**Technical Note in Response to LLFA Comments Regarding the
Discharge of Planning Conditions
for
Harlands Road, Haywards Heath, West Sussex, RH16 1LS**

Reference: 82960-01

1.1 This technical note has been prepared to respond to West Sussex County Council Lead Local Flood Authority comments regarding application DM/22/0596 and the Discharge of condition 4 relating to drainage.

RE: DM/25/1587 – NCP Ltd Harlands Road Car Park, Harlands Road, Haywards Heath, West Sussex

Title:
Drainage Design Layout

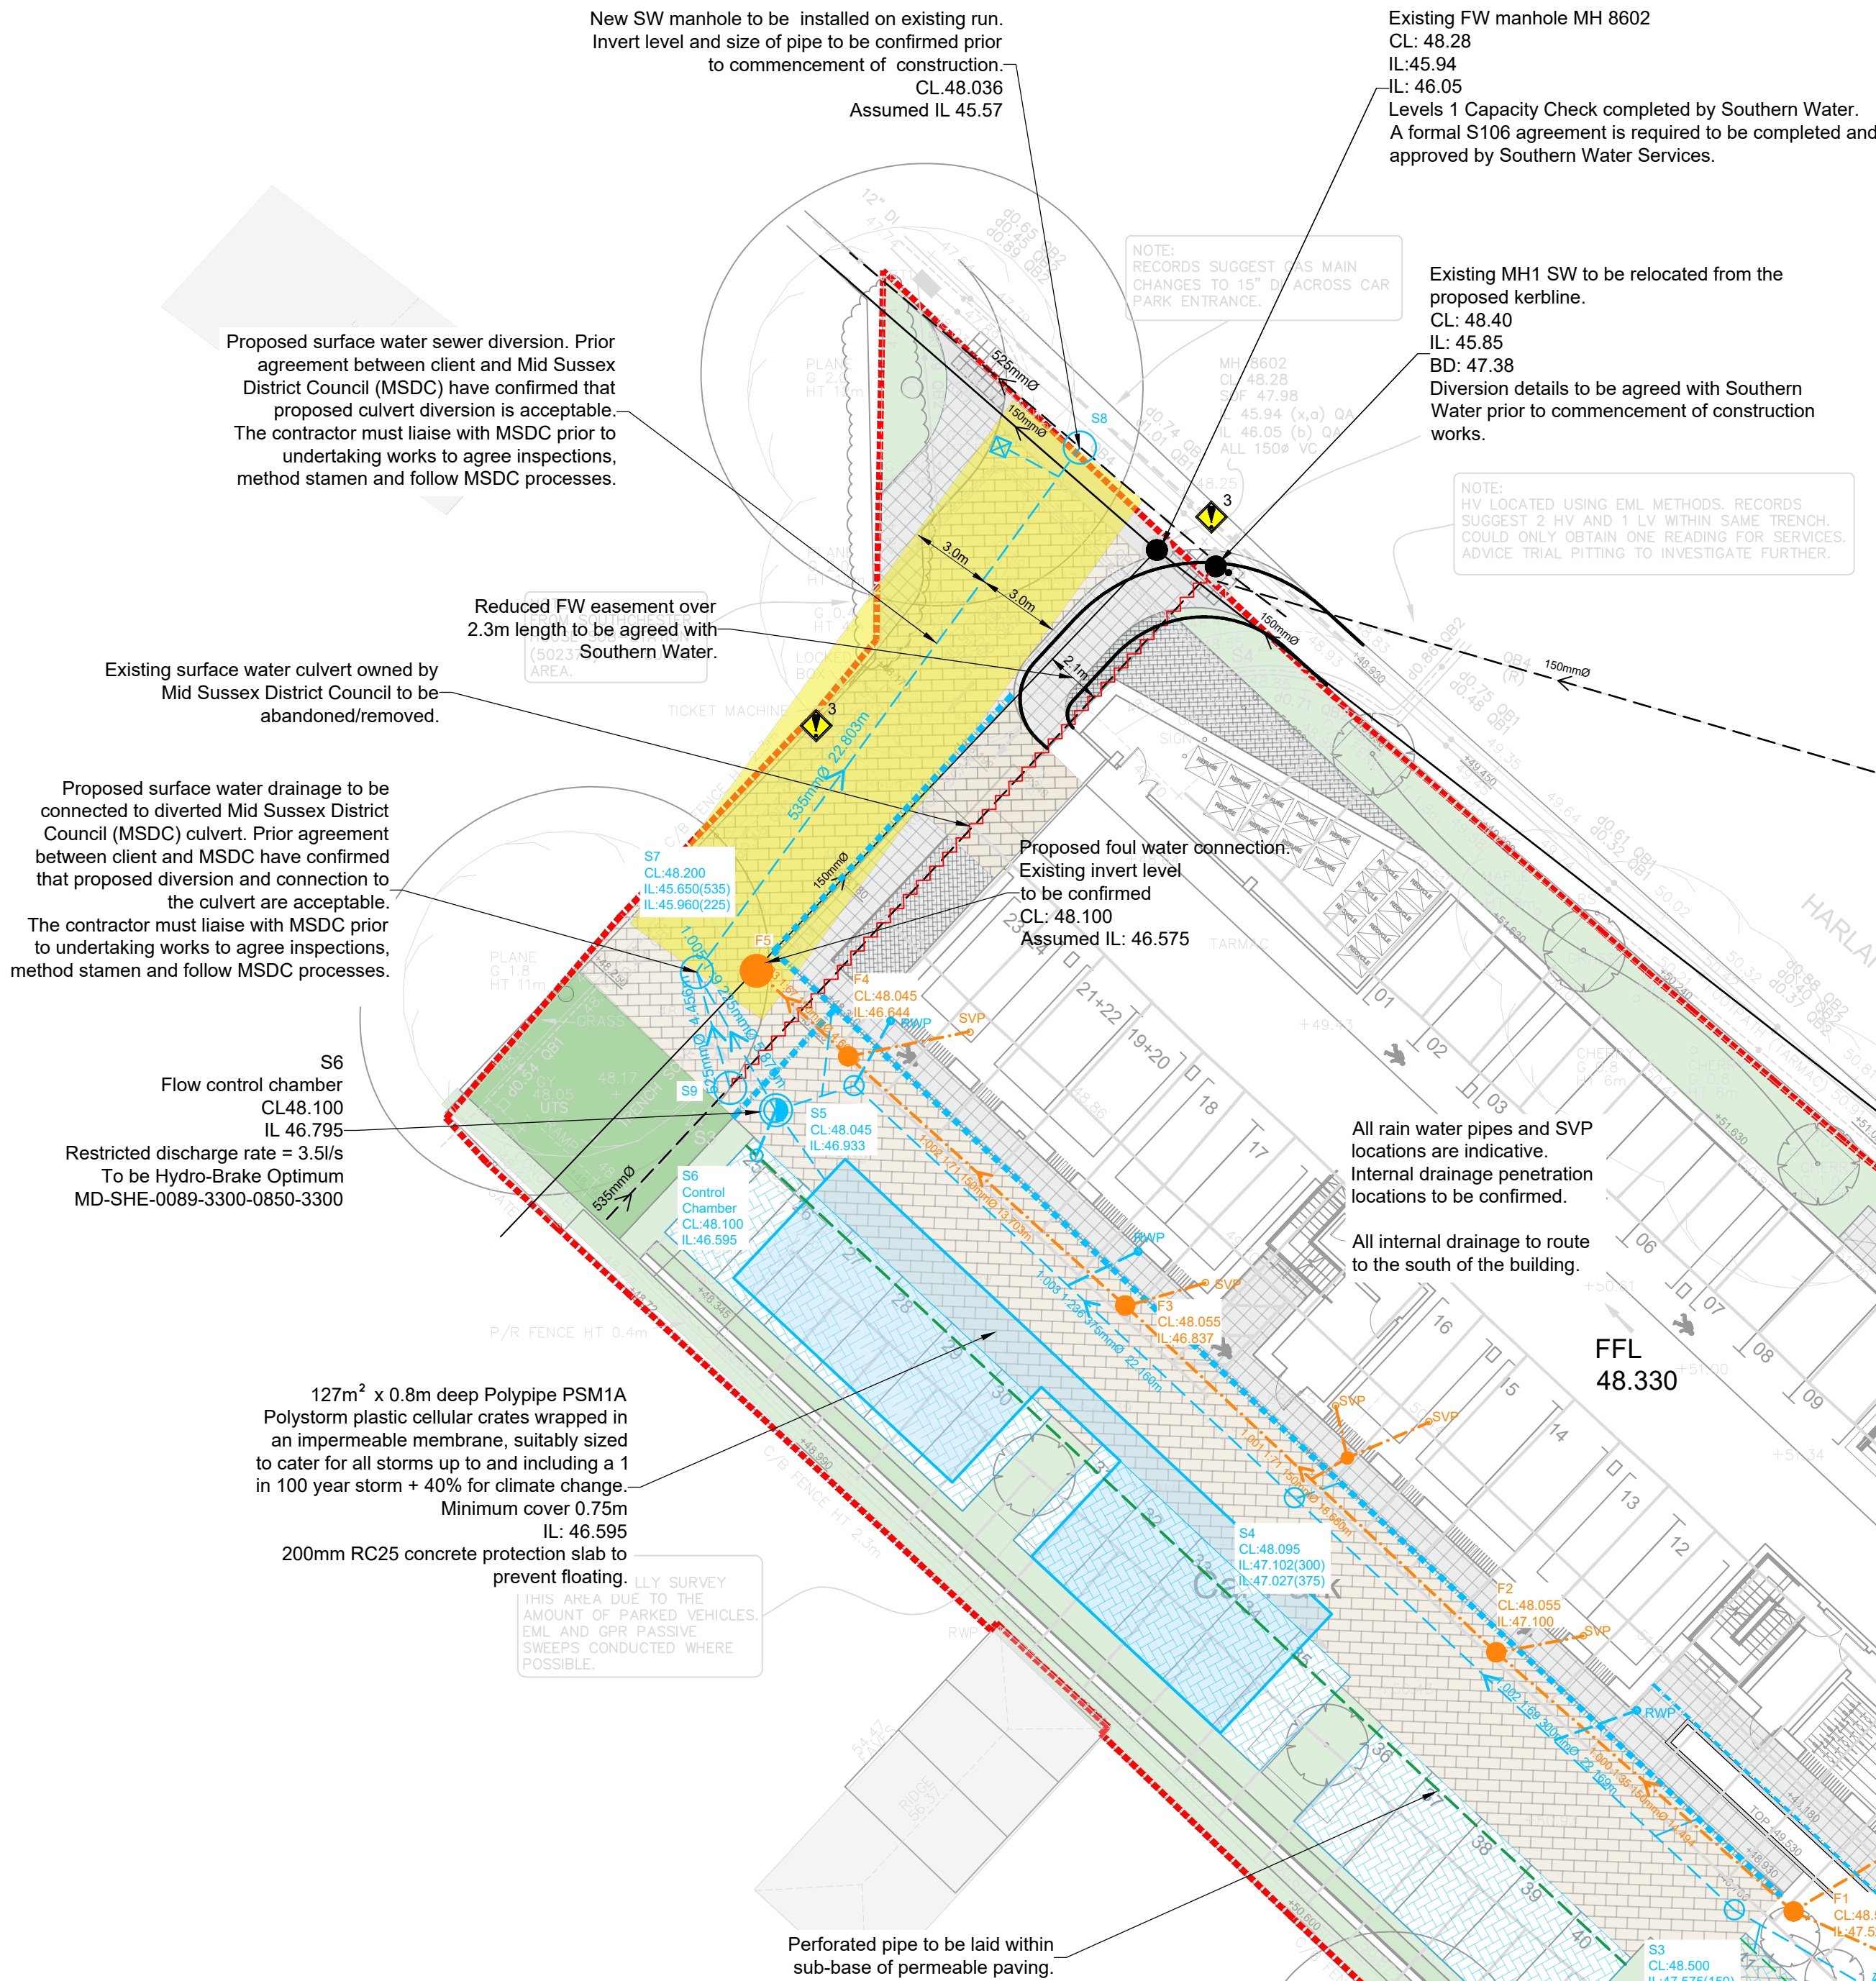
The Drainage Design Layout (prepared by PRP, 18 June 2025, REF 82960-100 REV P2) is still preliminary status. There are several 'subject to confirmation' notes including ones addressed to the LLFA. At discharge of condition stage, we would need to see all drainage layout items confirmed (i.e. cover and invert and volumes). Additionally, there is no finished floor levels on the building. The LLFA cannot identify whether these are the statutory 150mm above external ground levels or 300mm above the maximum design water level without them on the plan. Further information is required.

- The Drainage Design Layout (prepared by PRP, 18 June 2025, REF 82960-100 REV P2) is still preliminary status. There are several 'subject to confirmation' notes

including ones addressed to the LLFA. At discharge of condition stage, we would need to see all drainage layout items confirmed (i.e. cover and invert and volumes). Additionally, there is no finished floor levels on the building. The LLFA cannot identify whether these are the statutory 150mm above external ground levels or 300mm above the maximum design water level without them on the plan.

The Drainage Design Layout has been updated to include finished floor level, which is now shown on both the Drainage Design Layout and the External Works and Surfacing Plan. The drawing status has been revised accordingly.

Drawing notes have been expanded with additional descriptions to provide greater clarity. Correspondence with Mid Sussex District Council and Southern Water is included in appendix IV and V.

The revised Drainage Design Layout drawing is included in Appendix II for reference.

C1	16/09/2025	Drawing revised as per LLFA comments.	AZ / DE
P2	18/06/2025	Drawing revised as per latest hard landscaping plan	AZ / DE
P1	13/06/2025	Issued for comments	AZ / DE
Rev	Date	Description	By / Chk
